Application for Waiver from Construction Standards for Public Water Systems

In accordance with the above, the Los Aguilar Taqueria water system, PWS ID #91582, (plan review 63-2024) hereby requests the Oregon Health Authority to waive the construction standard OAR 333-061-0050 (2)(a)(E): Groundwater – Wells – “. . . No gravity sewer line ~~or septic tank~~ shall be permitted within 50 feet of a well which serves a public water system.”

PWS #91582
Los Augilar Taqueria

Evaluation Request for Plan Review, GWUDI Review, Setback Waivers, & Initial Monitoring Reductions

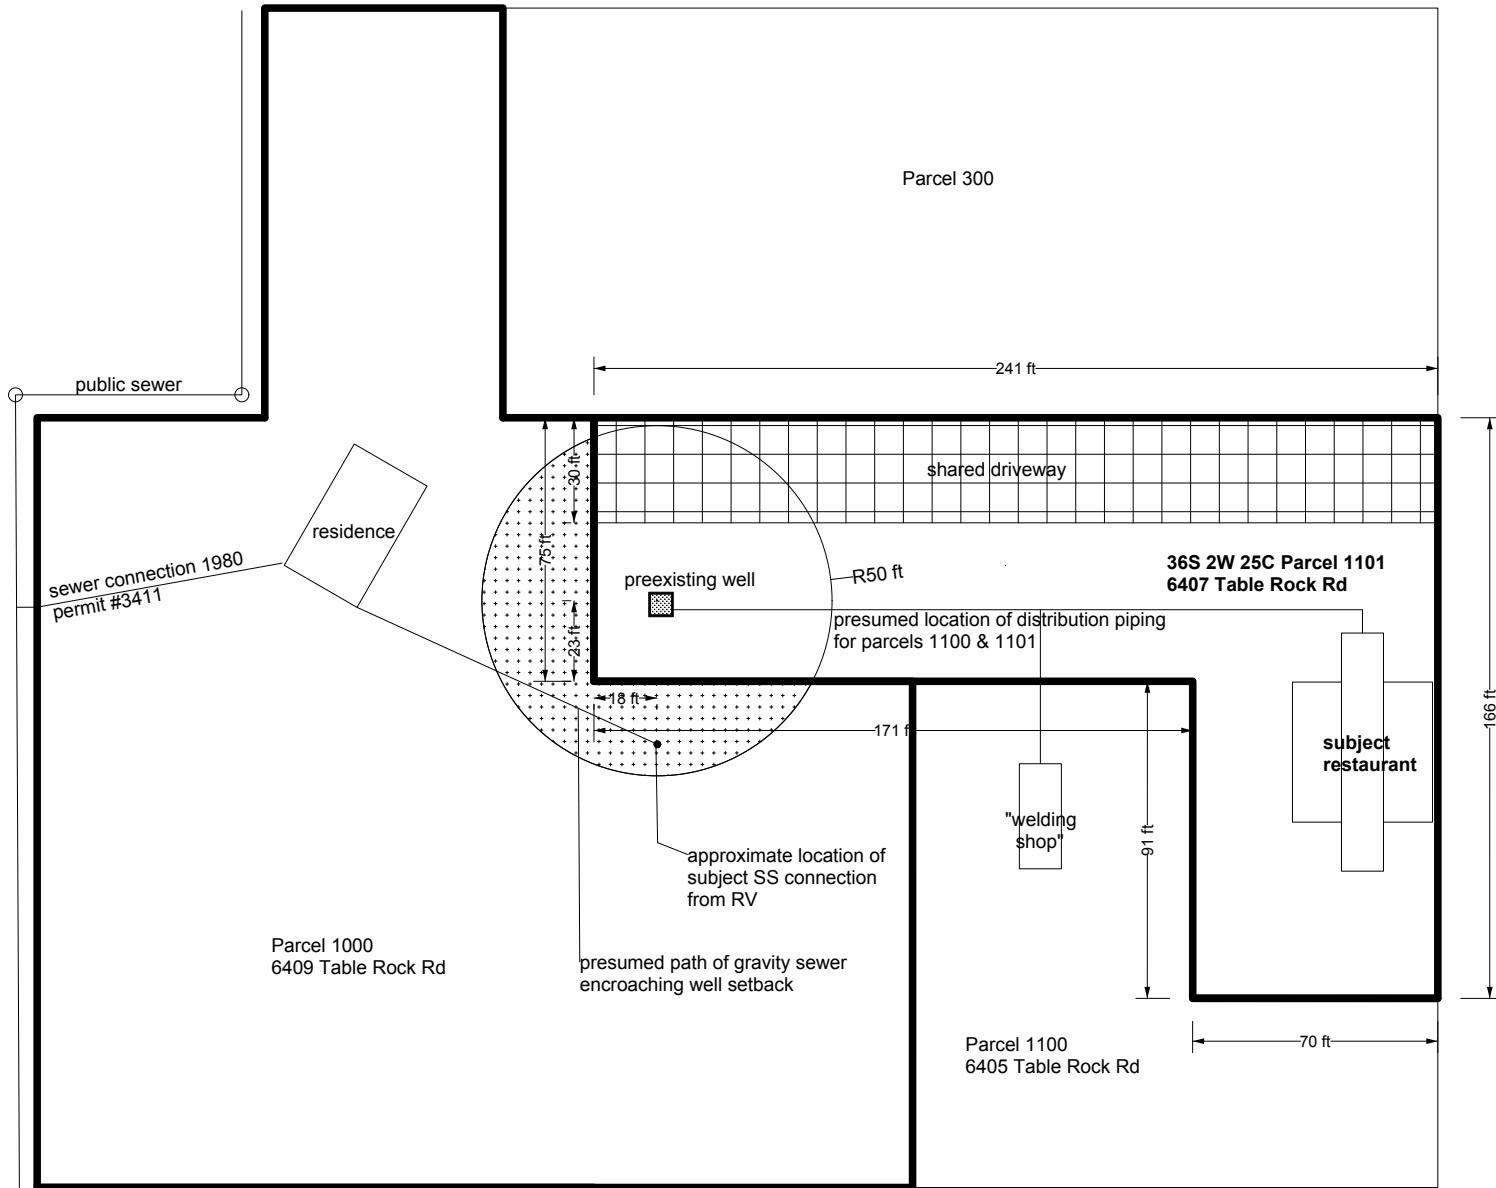
Please see attached site plan and well evaluation.

Comments: properly constructed well in a confined aquifer provides adequate alternative.
